Date: 18 July 2002
To: T10 Technical Committee
From: Ralph O. Weber
Subject: Rewrite of SAM-2 example for dependent logical units to remove SCC-isms

SAM-2 letter ballot comments (see 02-155r2) Cisco 10), Compaq 21), Exabyte 37), Exabyte 38), HP 61), and Maxtor 45) all raise issues regarding figure 23 (SAM-2 r23 PDF page 60) and the description of it. This proposal changes figure 23 and rewrites the text describing it in accordance with the current responses to these comments. The intent of this proposal is to allow CAP to review the result of the rewrite without having to pick through the comments responses.

Figure 1 — Example of hierarchical system diagram

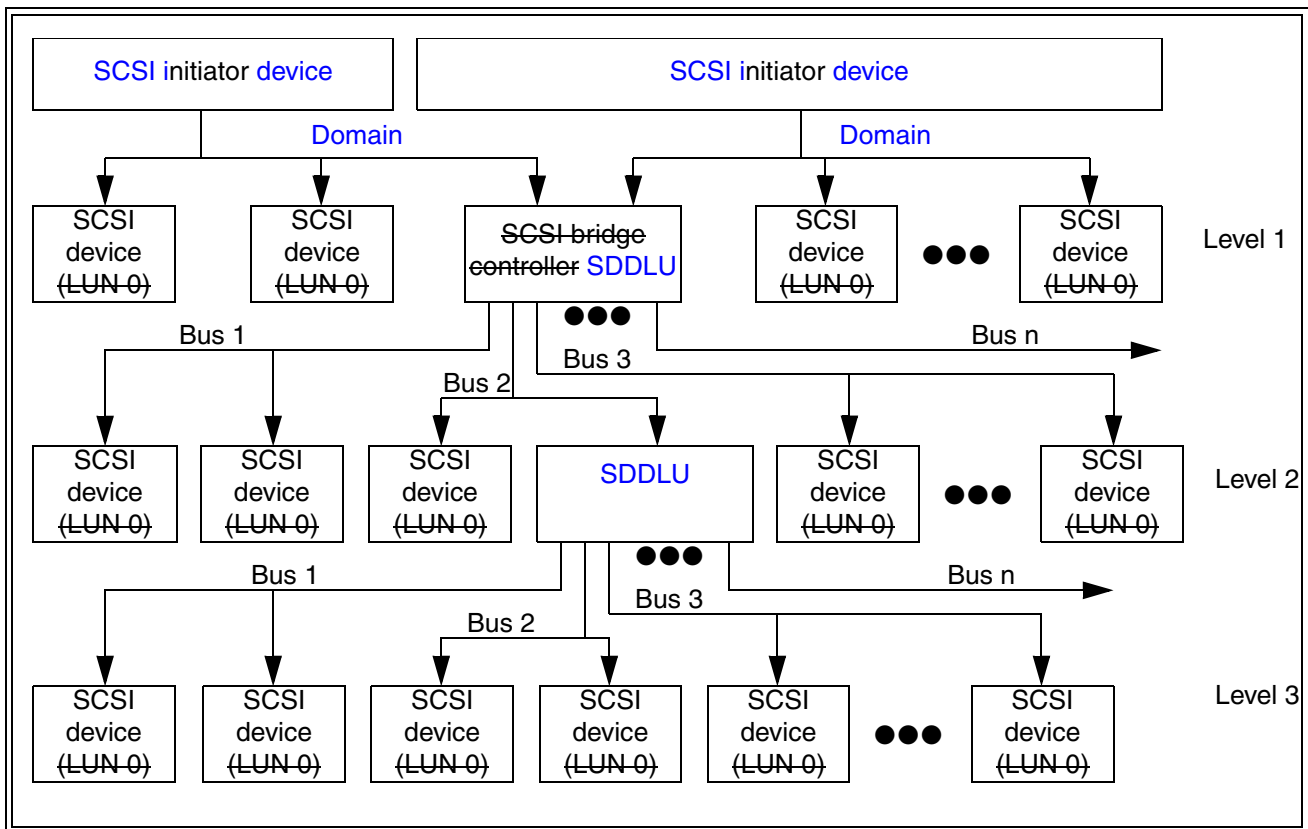
In r1, the word "Domain" has been added to the top to connection lines in the figure. No other changes have been made in r1.

As shown in figure 1, The hierarchical logical unit structure is an inverted tree containing up to four addressable levels. The example in figure 1 is a three-level system that consists of:

- a) One SCSI initiator device that has three SCSI target devices attached on in a single SCSI bus domain that is not expandable unable to add more SCSI target devices. One of the SCSI target devices is a dual ported SCSI bridge controller the level 1 SDDLU. The level 1 SDDLU has two SCSI target ports, one in each of the SCSI domains containing a SCSI initiator device-;

- b) One SCSI initiator device has three SCSI target devices attached in a single SCSI domain that is expandable able to add more SCSI target devices. One of the SCSI target devices contains is a dual ported SCSI bridge controller the level 1 SDDLU;

- c) The level 1 SDDLU has three SCSI domains (called buses for hierarchical addressing purposes) with SCSI target devices attached and is capable of driving connecting more SCSI domains;

- A) Two of the SCSI domains contain two SCSI target devices each and these SCSI domains are unable to add more SCSI target devices. One of the SCSI target devices is the level 2 SDDLU;

- B) One of the SCSI domains contains two SCSI target devices and is able to add more SCSI target devices;
- C) The level 2 SDDLU has three SCSI domains with SCSI target devices attached and is capable of connecting more SCSI domains;

- a) Two of the SCSI domains contain two SCSI target devices each and these SCSI domains are unable to add more SCSI target devices; and
 - b) One of the SCSI domains contains two SCSI target devices and is able to add more SCSI target devices.
